PLANNING COMMISSION

To: Santaquin City Planning Commission
 From: Jon Lundell, P.E., City Engineer
 Date: January 9, 2025
 Re: **Santaquin City Standards and specifications update**

Standard Specifications and Drawings

2024 Standard and Specifications and Drawings Updates

4" WATER SERVICE CONNECTION
SANTAQUIN CITY
110 SOUTH CENTER STREET

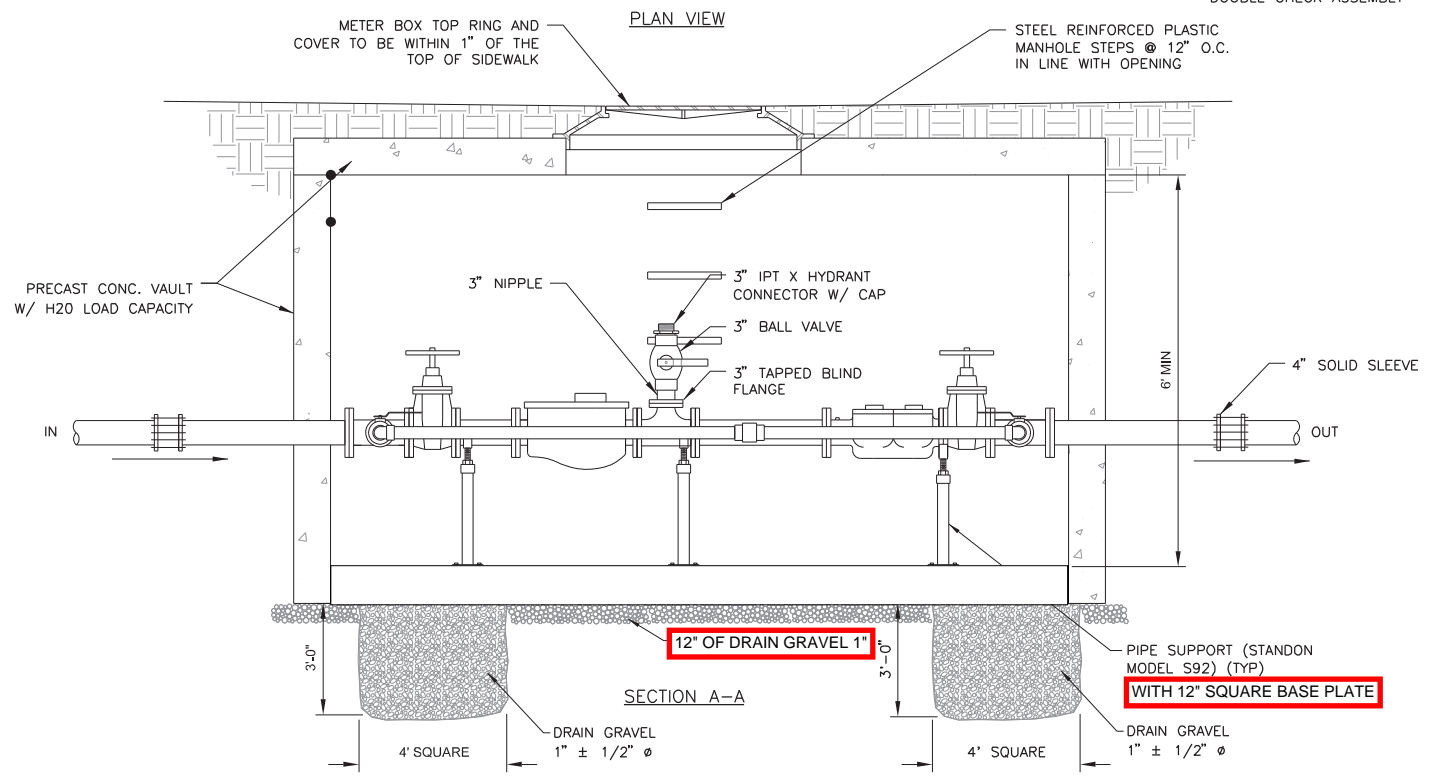
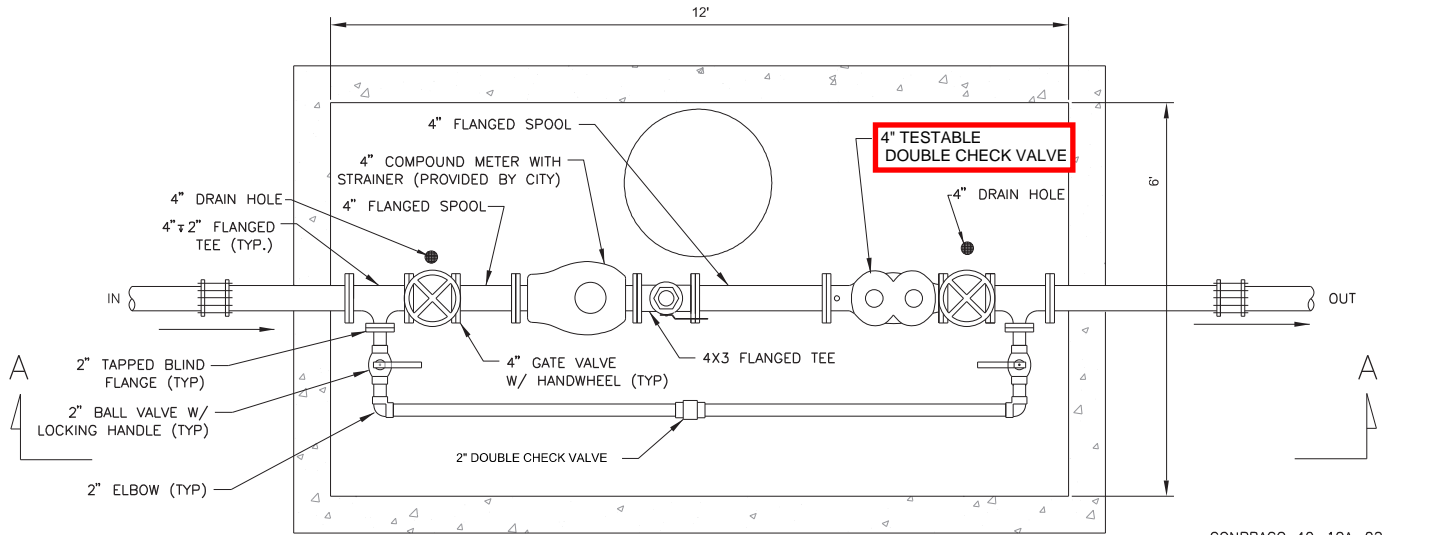
- ii. Pavilion requirements.
9. Standard Drawings
 - a. All Drawings: Update the title block
 - b. W3 – update label for a double check valve to be testable

- c. PI2 – Update label to match text
 - d. W3 – Added pipe between meter boxes to match text
 - e. W7 – Remove label that states 2” PVC blow off assembly.

- All Drawings: Update title block to show current address
- W3 Update the label on 4" Double check valve to state that it must be testable
- PI2 change label on conduit between meter boxes to match specification text
- W7: Remove label that says 2" PVC on the Eclipse Hydrant Blow-Off Assembly and replace with 2" ductile iron
